## **2.5 Geology, Seismology, and Geotechnical Engineering**

PSEG Site early site permit (ESP) application, Section 2.5, “Geology, Seismology, and Geotechnical Information,” of the Site Safety Analysis Report (SSAR), Revision 3, contains information on geologic, seismic, and geotechnical characteristics of the proposed ESP Site. The applicant (PSEG) followed guidance in Regulatory Guide (RG) 1.208, “A Performance Based Approach to Define Site-Specific Earthquake Ground Motion,” to define the following four zones around the site and conducted investigations in those zones that became progressively more detailed passing from site region to site location:

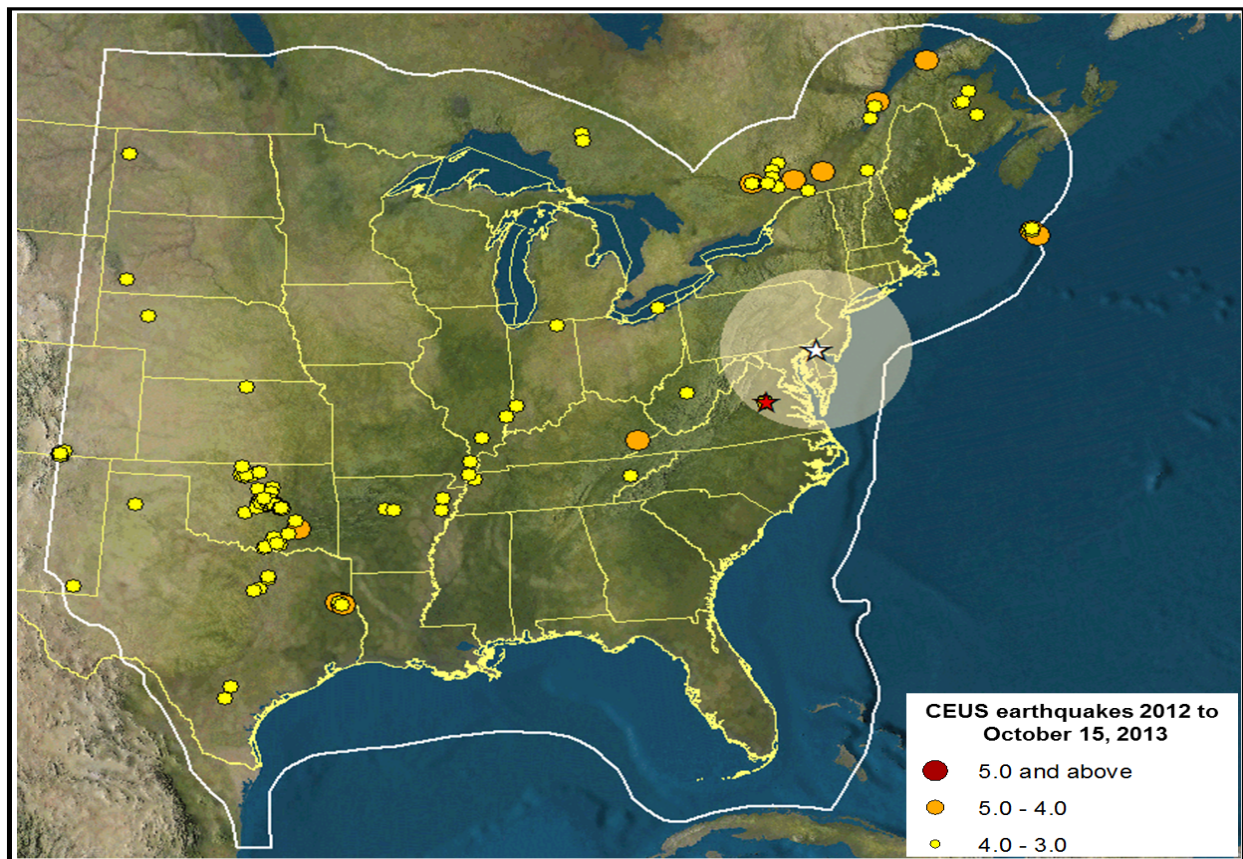
window covering 2009 through October 15, 2013, throughout the CEUS as defined by NUREG-2115. The staff's supplementary earthquake catalog confirmed that the applicant adequately updated its catalog from 2009 through 2011. In addition, the staff's catalog showed that there are 173 earthquakes in the CEUS region (Figure 2.5.2-6 of this report) that occurred between 2012 and October 15, 2013. None of these earthquakes have moment magnitudes (**M**) equal to or greater than **M5.0**. The staff identified 15 earthquakes in the range between **M4.0** and 4.9 distributed over the CEUS region. The majority of the earthquakes (158 of the 173) in the updated catalog are small magnitude earthquakes (**M** < 4.0). Therefore, the staff concludes from its confirmatory analysis that the earthquakes in the staff's supplementary catalog are located within identified active CEUS seismic regions and do not add any new information to the catalog used by the applicant.

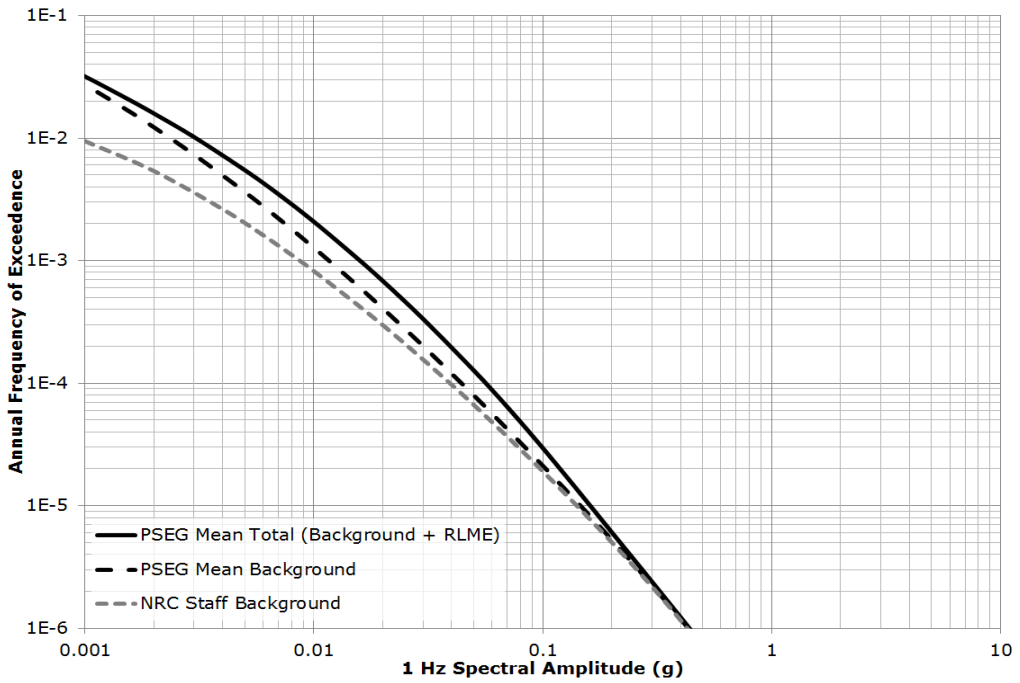
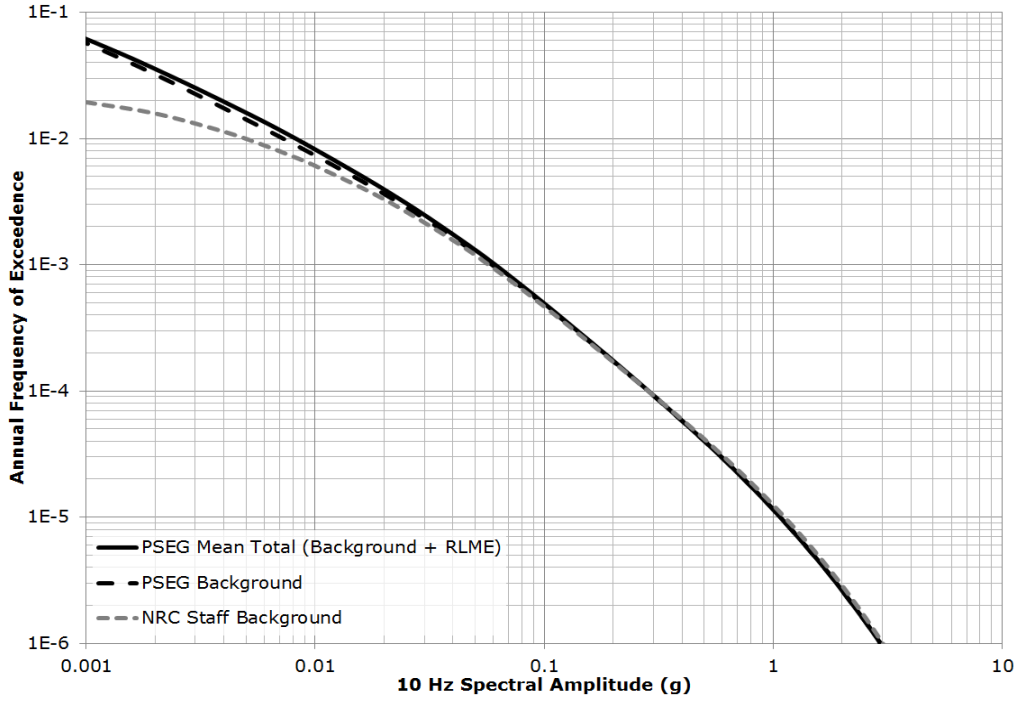
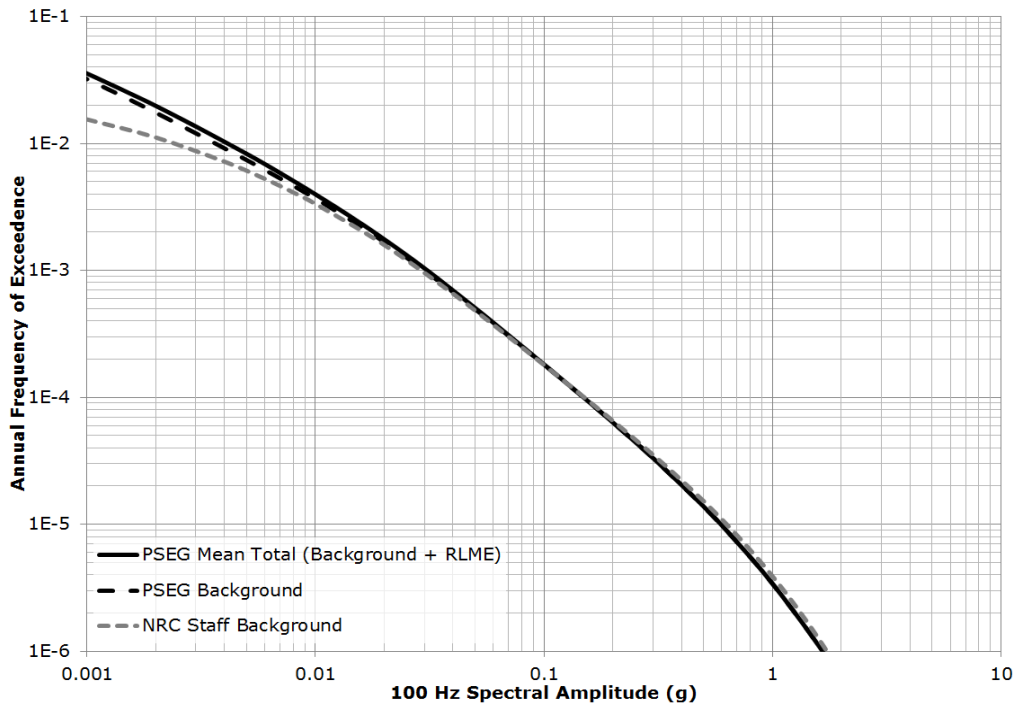
As part of its confirmatory analysis, the staff used the NUREG-2115 CEUS-SSC model background (distributed seismicity) sources and independently calculated the seismic hazard curves at the PSEG Site for all seven ground motion frequencies defined in the EPRI (2004, 2006) ground motion prediction models. The staff's confirmatory calculations did not include the RLME sources. These sources exist at distances beyond 800 km (500 mi) from the PSEG Site and are expected to contribute only at low frequencies such as 0.5 and 1 Hz. From the NUREG-2115 seismic source model, the staff first selected all background seismic sources that are within the 320 km (200 mi) the site region. For those seismic sources which are partly within the 320 km (200 mi) site region, but with boundaries extending beyond the site region, the staff used a distance cut off of 500 km (312 mi). Beyond that distance, their hazard contributions will be negligible. Figure 2.5.2-7 of this report shows the staff's results as compared to the applicant's for PGA and ground motion frequencies of 10 and 1 Hz. The staff's confirmatory calculations show that for the annual frequency of exceedances of  $10^{-4}$ ,  $10^{-5}$ , and  $10^{-6}$ , the staff's seismic hazard curves are in good agreement with the applicant's background seismic hazard curves. The difference observed between the background seismic source hazard curves and the total seismic hazard curve at 1Hz shown in Figure 2.5.2-7 of this report is attributed to the contribution of the RLME seismic sources at large distances. As shown in SSAR Figures 2.5.2-25 through 2.5.2-30, at low frequencies, such as 2.5, 1, and 0.5 Hz, distant RLME sources contribute to the hazard at the site. In contrast, at high frequencies only local sources contribute to the hazard. Based on this analysis, the staff concludes the applicant adequately characterized the mean seismic hazard at the PSEG Site.

**Figure 2.5.2-8 Comparisons of the staff's site response amplification function with the amplification function determined by the PSEG applicant for the 10-5 annual frequency of exceedance**

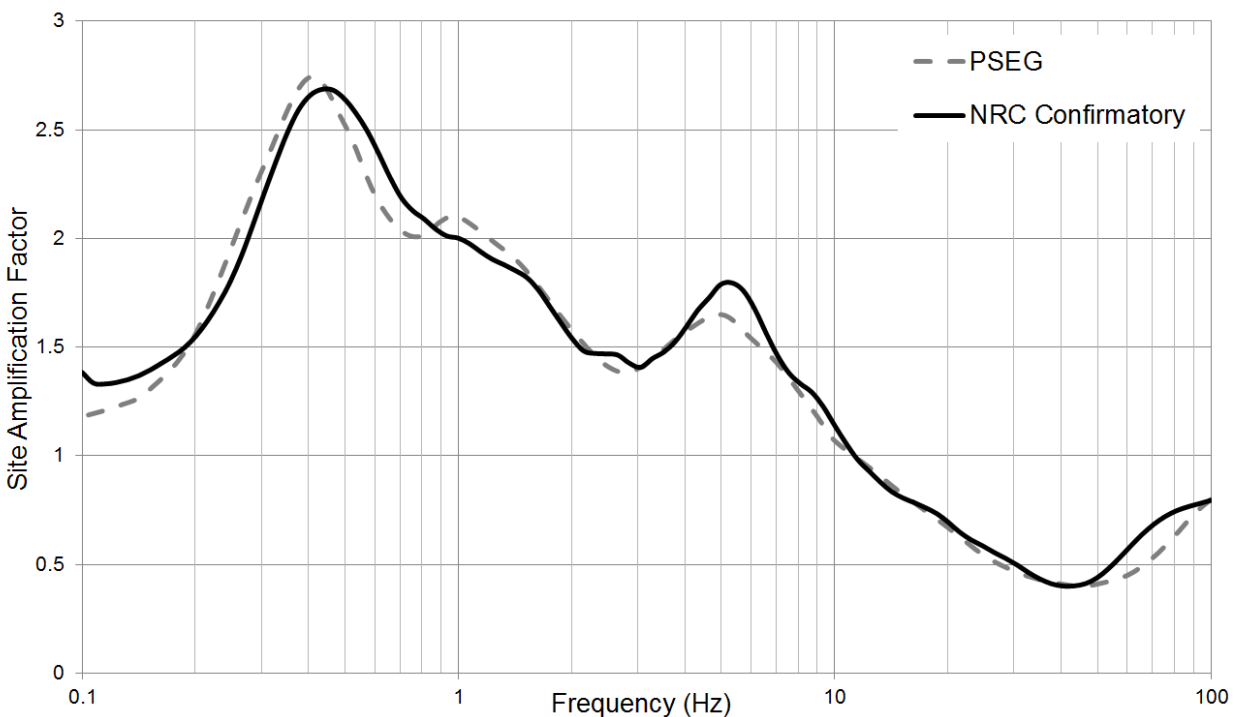
To determine the adequacy of the applicant's site response calculations, the staff performed its own confirmatory site response calculations. As input, the staff used the static and dynamic soil properties provided in SSAR Section 2.5.4. To represent the input rock motions, the staff used the applicant's low- and high-frequency  $10^{-5}$  rock spectra. The staff performed its site response calculations using the Strata software (Kottke and Rathje 2008). The staff's site amplification function results are compared with the applicant's results in Figure 2.5.2-8 of this report, which shows that the staff's calculation is similar to the applicant's site amplification factor across the frequency range typically important for engineering purposes (i.e., 0.5 to 10 Hz) and they are within the limits of uncertainties expected from these calculations. Based on this assessment, the staff concludes that the applicant's site response calculations adequately characterize the site effects at the PSEG Site.
